Wollongong Local Planning Panel Assessment Report | 8 March 2022

WLPP No.	Item No.1
Integrated DA No.	DA-2021/796
Proposal	Residential – alterations and additions to dwelling, and swimming pool
Property	Lot 16 DP 285763 2 Weaver Terrace, Bulli NSW 2516
Applicant	PRD Architects
Responsible Team	Development Assessment & Certification Team - Building and Certification Team (EF)

ASSESSMENT REPORT AND RECOMMENDATION

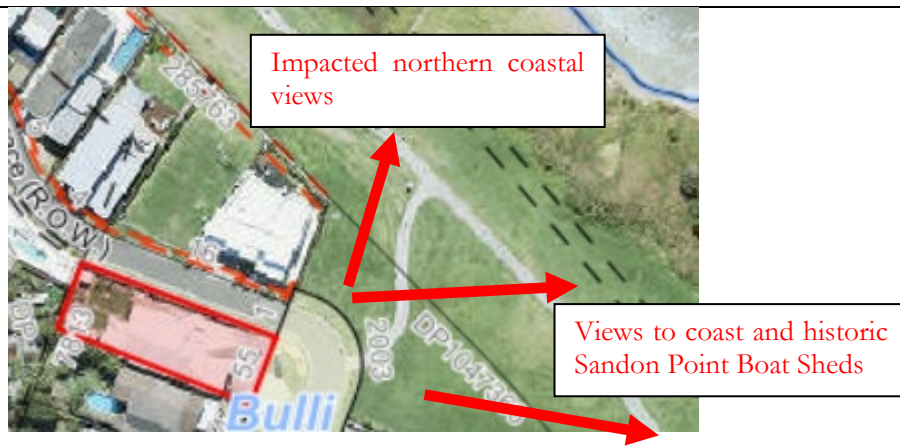
The site is located immediately adjacent to an existing public view corridor, which combined with the proposed building setback, will provide a view corridor on the immediately adjoining site with a width greater than 4 metres and unencumbered with any structures and significant vegetation. Refer to below image:

It is noted that the subject site is located immediately adjacent to a significant unencumbered view corridor on the adjoining site to the east of the subject property, which is community land owned by Wollongong City Council.

Title:
FSR AND SITE COVERAGE CALCULATION PLAN

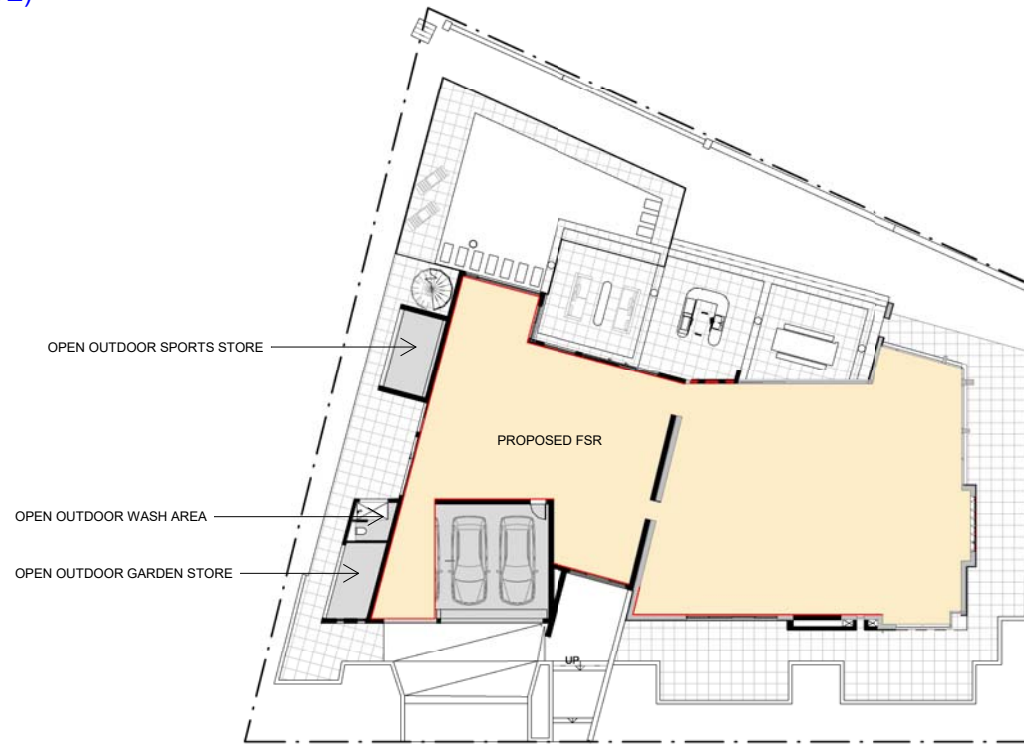
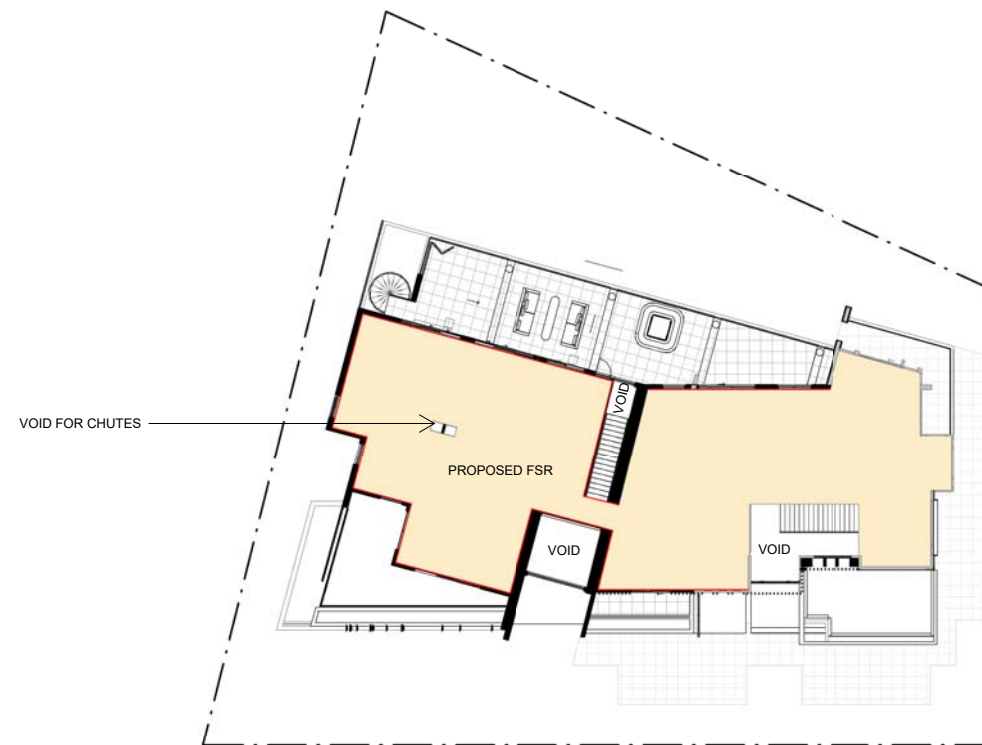
- Concerns raised during notification.
- Building character and form.
- The proposed dwelling exceeds the maximum permissible 0.50:1 Floor Space Ratio (FSR) permissible for the site, as prescribed by Clause 4.4 of Council's Wollongong Local Environmental Plan 2009.

2. Floor Space Ratio	<p>Council’s assessment of the application confirms that the proposed development exceeds the maximum permissible FSR of 0.50:1 for the site. The proposed development proposes an FSR of 0.53:1, which is an exceedance of 6%. Council does not support the proposed FSR.</p> <p>Refer to Section 2.1.5 of this report assessment of floor space ratio and assessment of <i>Clause 4.6 – Exception to development standards</i>.</p>

It is recommended that DA-2021/796 be Refused for the following reasons:

1. Pursuant to the provisions of Section 4.15(1)(a)(i) of the Environmental Planning and Assessment Act 1979, it is considered that the proposed development exceeds the maximum

permissible Floor Space Ratio (FSR) of 0.50:1 as prescribed by Part 4.4 – Floor Space Ratio, Wollongong Local Environmental Plan 2009, and is contrary to the objectives of this clause, as:
